**TAKE NOTICE THAT A REGULAR MEETING
OF THE BOARD OF COMMISSIONERS
OF THE CITY OF PHARR, TEXAS
WILL BE HELD AT CITY HALL, COMMISSIONERS' ROOM,
118 S. CAGE BLVD., 2ND FLOOR, PHARR, TEXAS
COMMENCING AT 4:00 PM ON
MONDAY, DECEMBER 1, 2025**

E) Consideration and action, if any, on Change Order Number 2 in the amount of \$49,781.94 and the addition of 15 working days to the construction contract with D. Wilson Construction Company for the Donation Acceptance Program for Fiscal Year 2016. **This item supports IF - Infrastructure.** (ENGINEERING)

**Project: 24-235 Pharr FY16 DAP - Agricultural
Lab, Dock Expansion I & II**
9901 S Cage Blvd
Pharr, Texas 78577

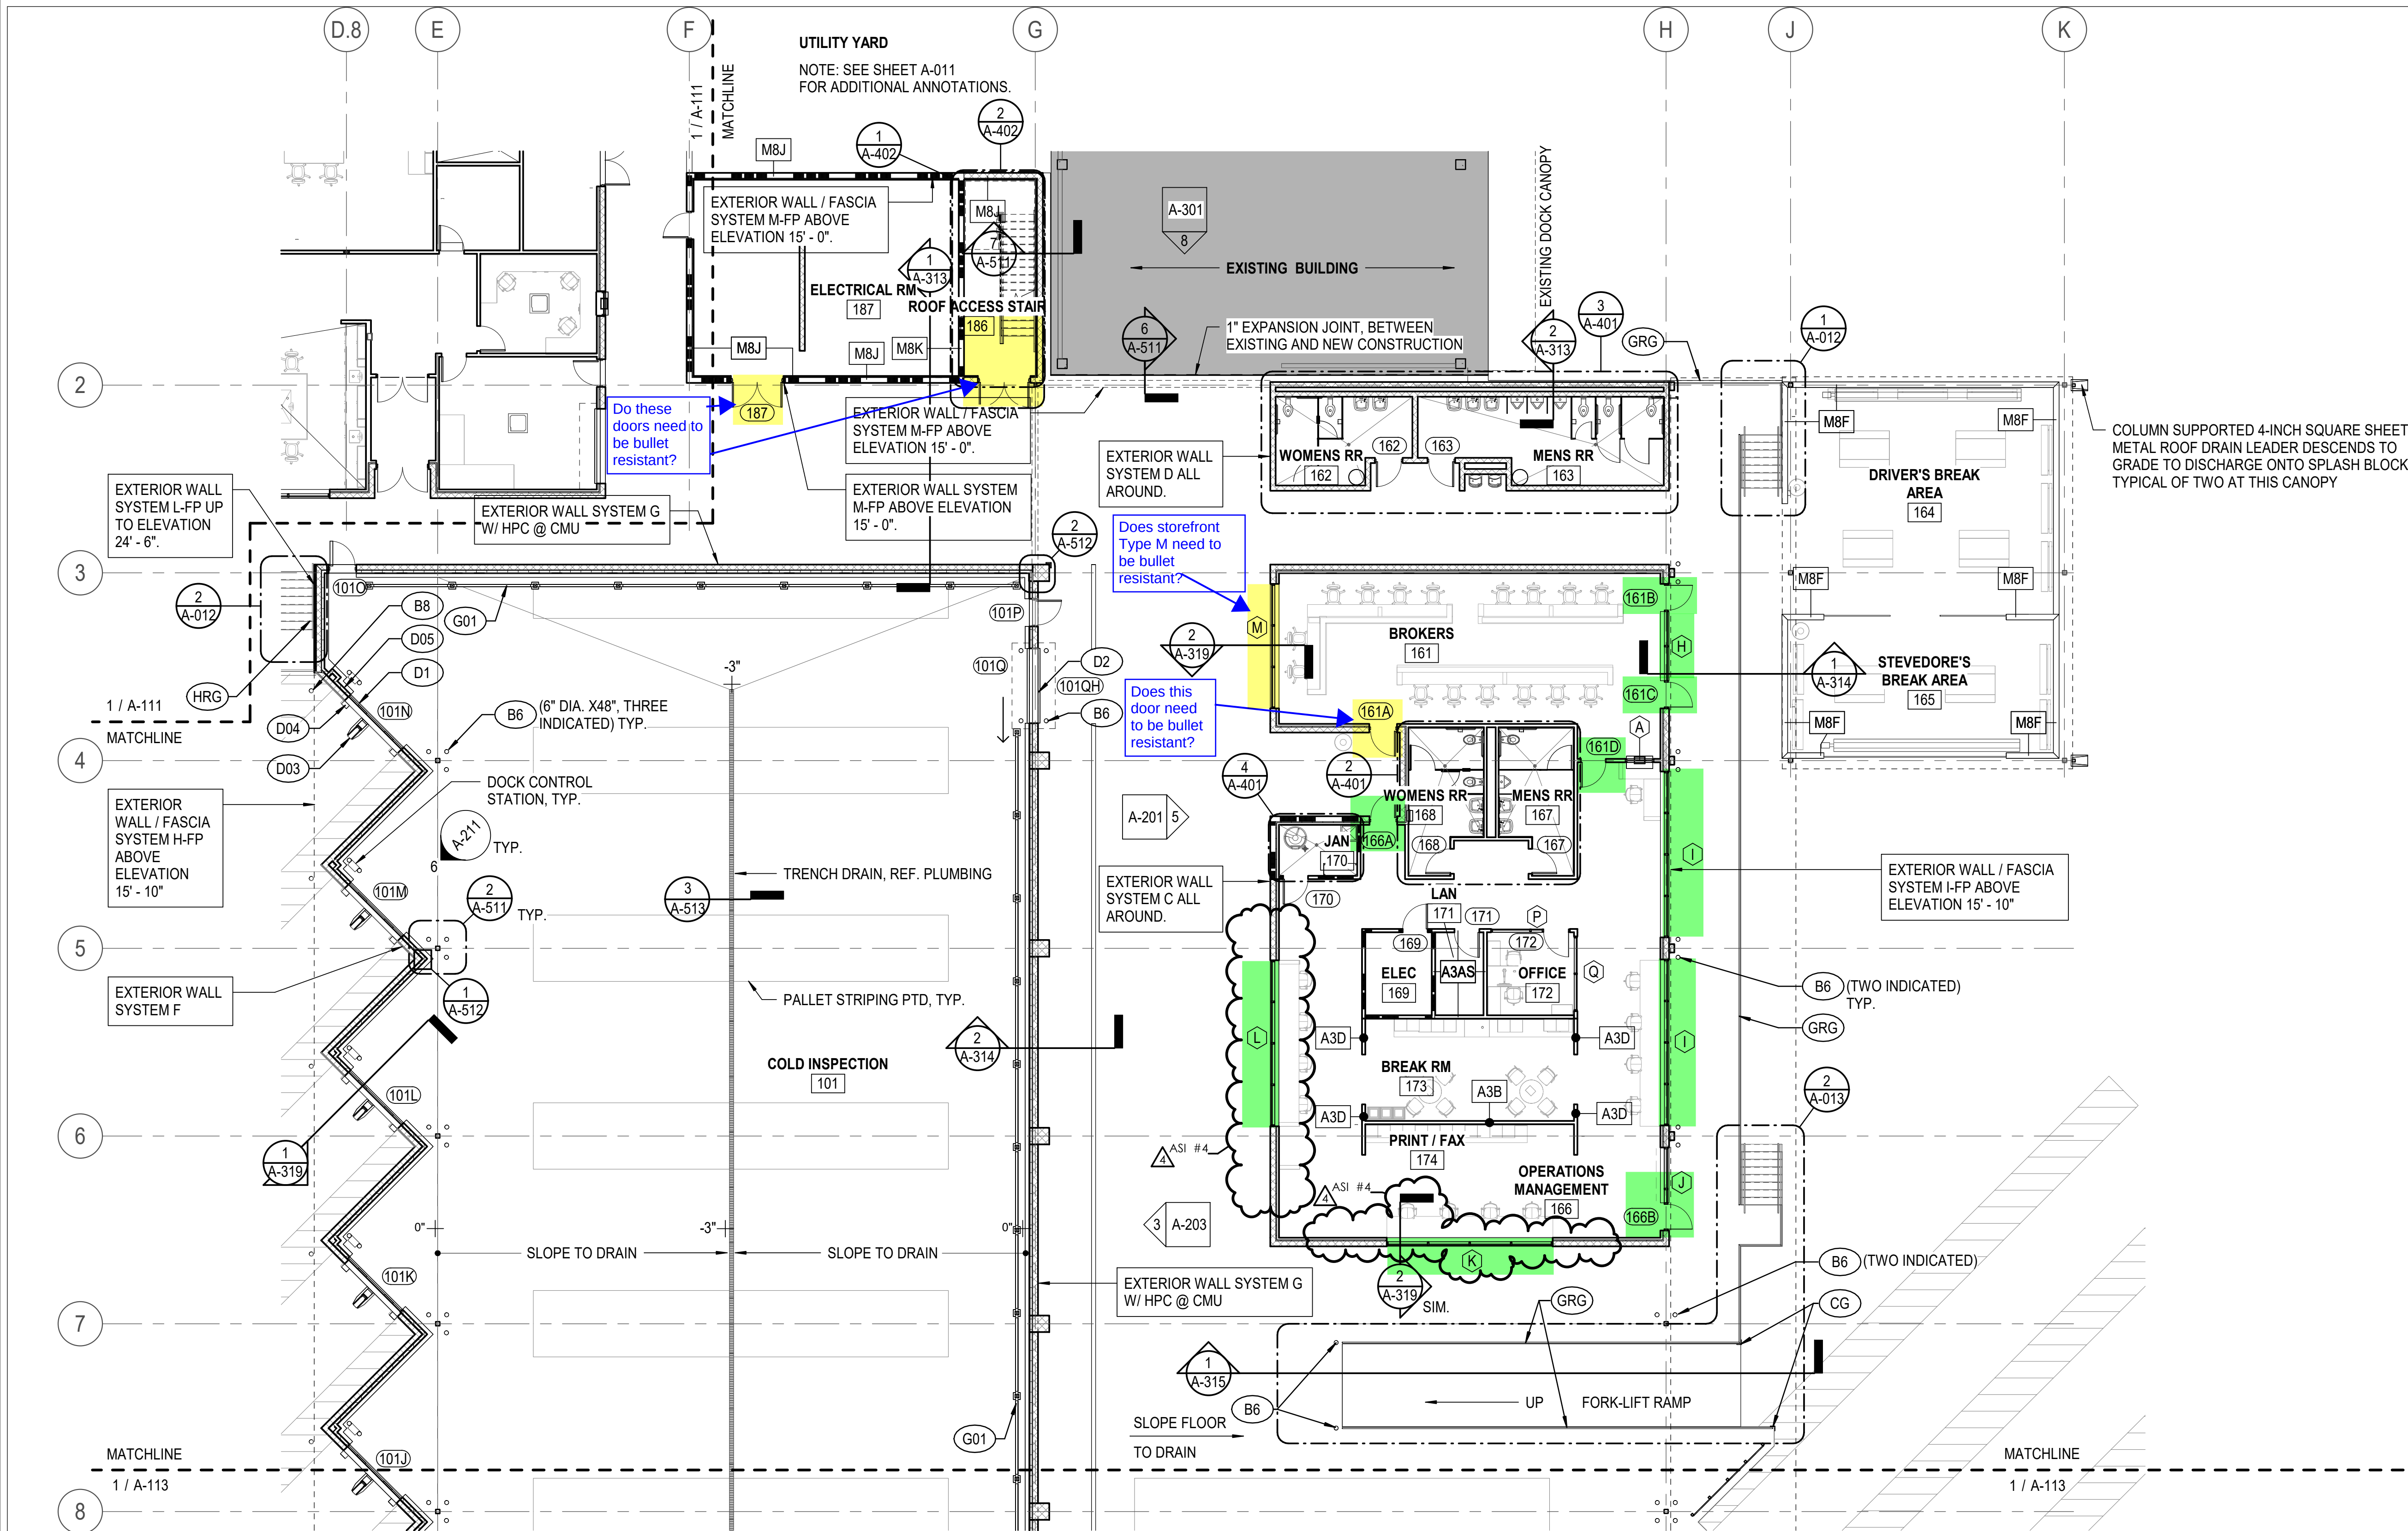
1. Reduce length of Window Type K and Window Type L, located in Operations Management 166 and Break Rm 173 respectively, as indicated in attached exhibit drawings A-112, A-116, A-201, & A-611.

2. Infill with matching adjacent (CMU) wall type with associated interior and exterior finishes, as indicated in attached exhibit drawings A-112, A-116, A-201, & A-611.

3. Strengthen non-existing steel columns of Grid E 16 as indicated in attached exhibit drawing A-114. Some columns (Grid E 16) shown in project Construction Drawing Sheets A-101, A-134, A-301, A-301, A-301, & I-104 (but not included in attached exhibit) are also designated.
